WEST WINDSOR TOWNSHIP

MEMORANDUM

SUBJECT: **400 Steps, LLC**
Preliminary/Final Site Plan
Block 5, Lots 19 & 20
#15 Cranbury Road (rear) (Mercer County Route 615)
PB20-05

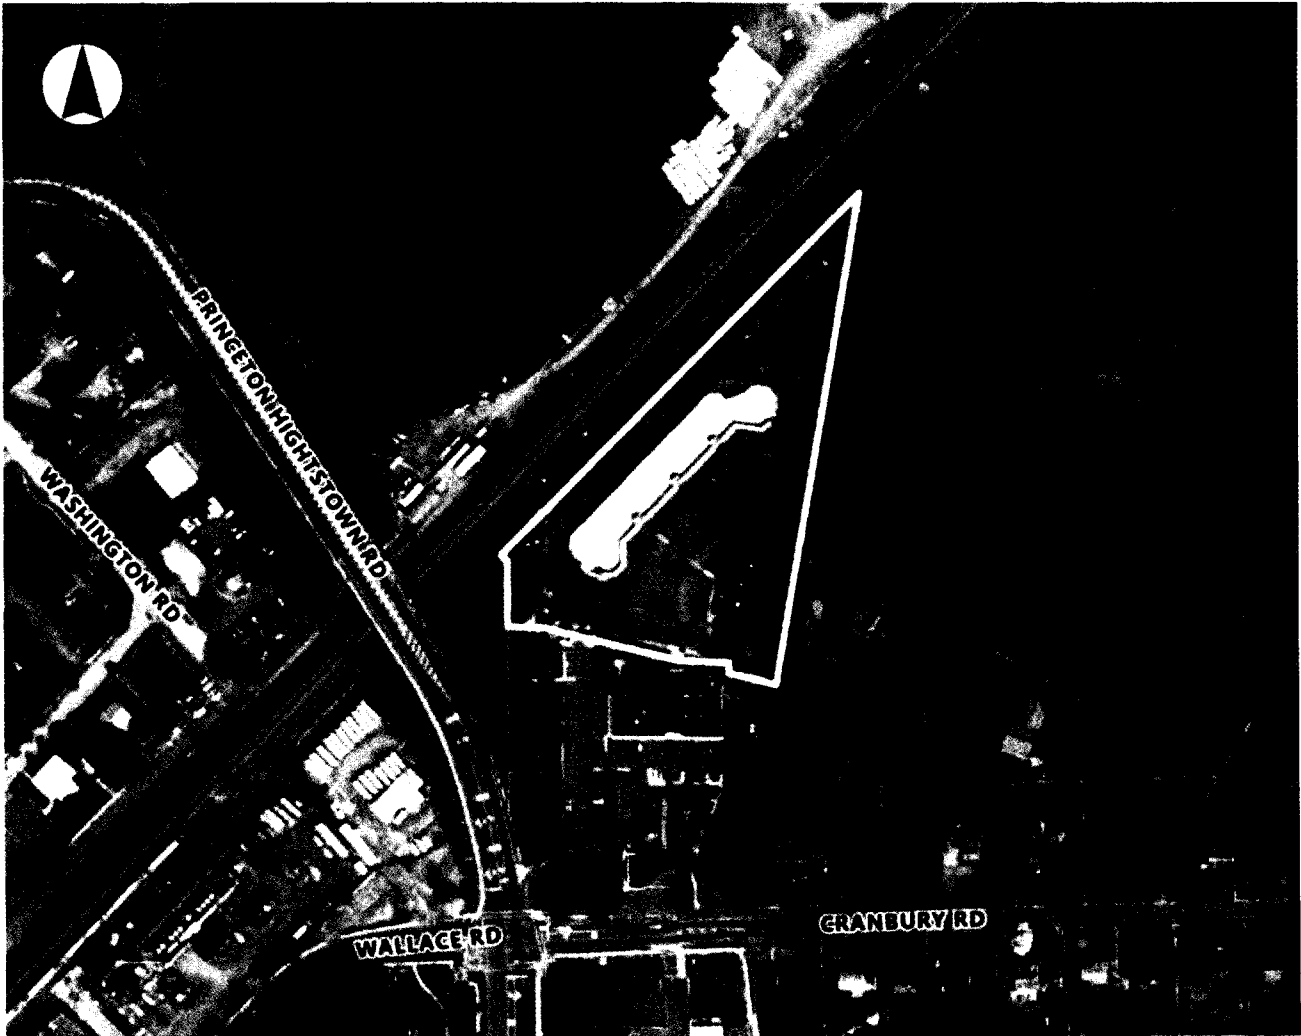
Two crosswalk details are provided on Sheet 11: one which shows a special ground treatment, and one which utilizes typical striping. Based upon Sheet 4, it appears as though the crosswalks in the main project area will utilize the decorative pattern, thus satisfying this requirement. This should be confirmed by the applicant.
